DOCUMENT 00 00 13

ADDENDUM NO. 3
August 30, 2024

Customs and Border Protection (CBP) Federal Inspection Service (FIS) Facility Renovation
City of Duluth Project No. 24-4401
Duluth International Airport
Duluth, MN

3A / A110 FIRST LEVEL ENLARGED FLOOR PLAN - FIS SECONDARY
1/4" = 1'-0"

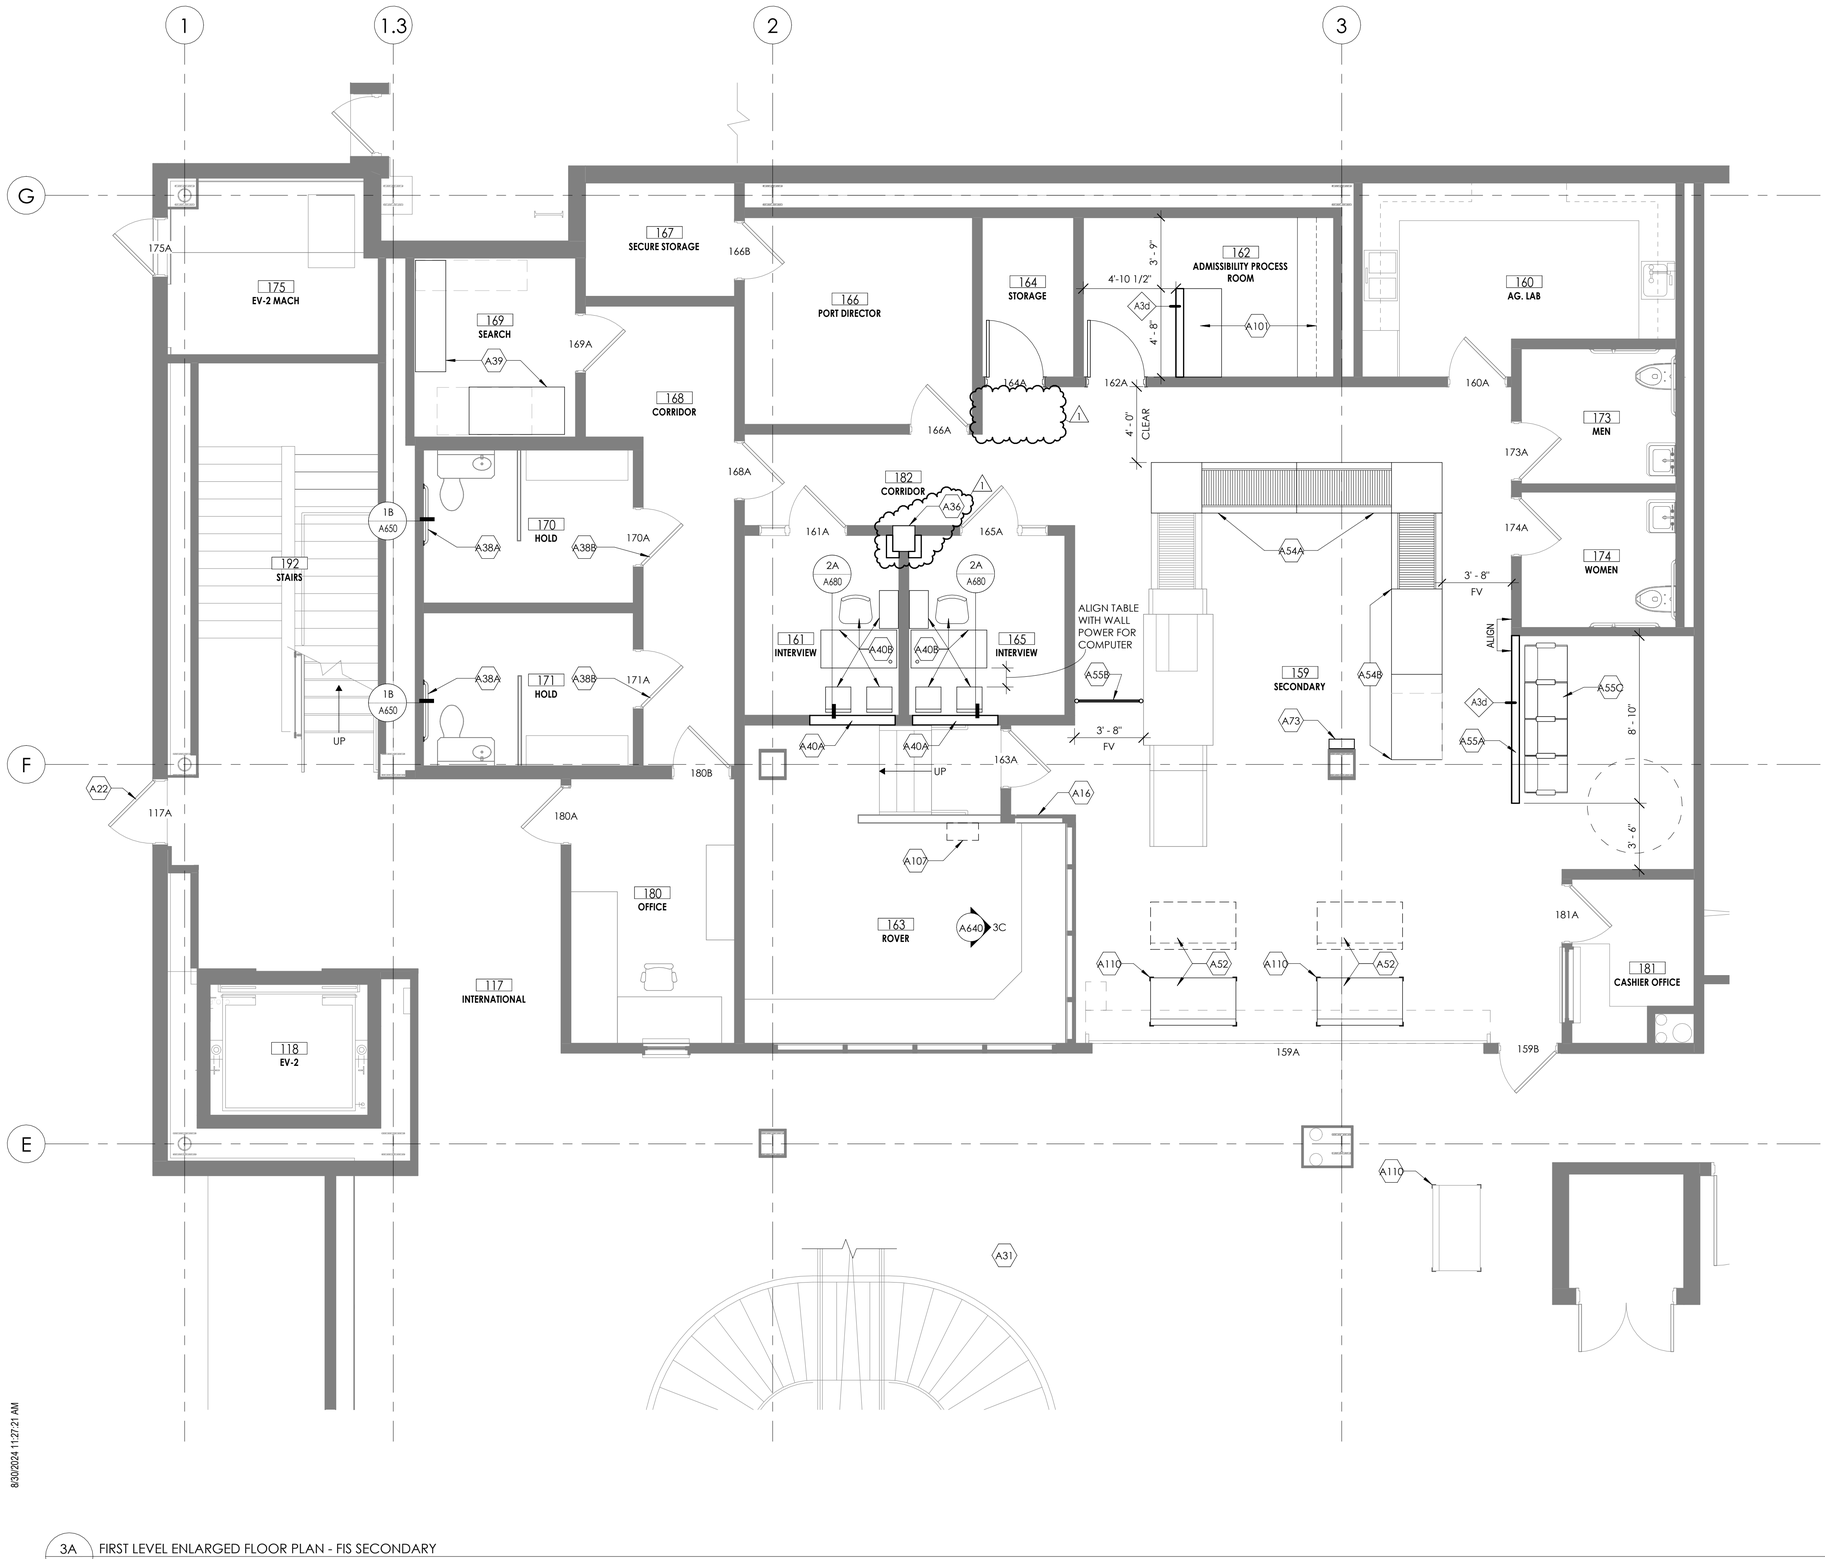
2. A110 – First Level Floor Plan Enlarged – Remove and replace with attached drawing. Shows handgun locker location.

1. Keynote A110 notes "SS Corner Guards on Podiums" - 3x mobile podiums.

Figure 1

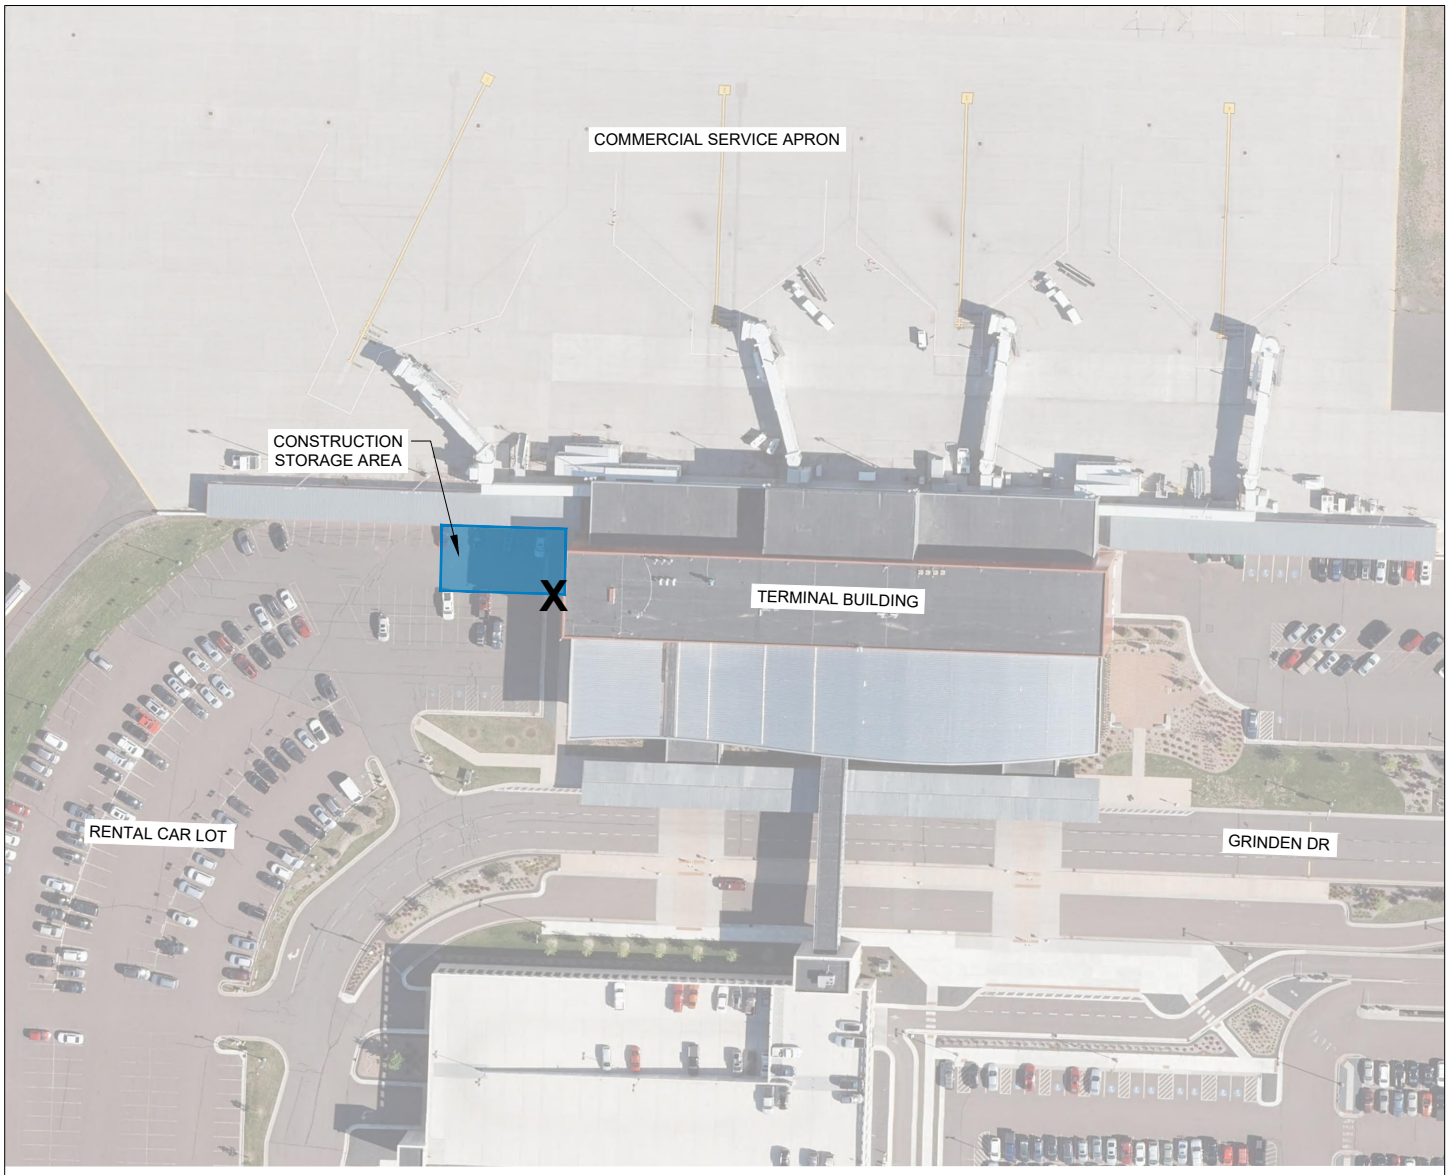
9. Figure 1 attached to show construction storage area and location of work site entrance
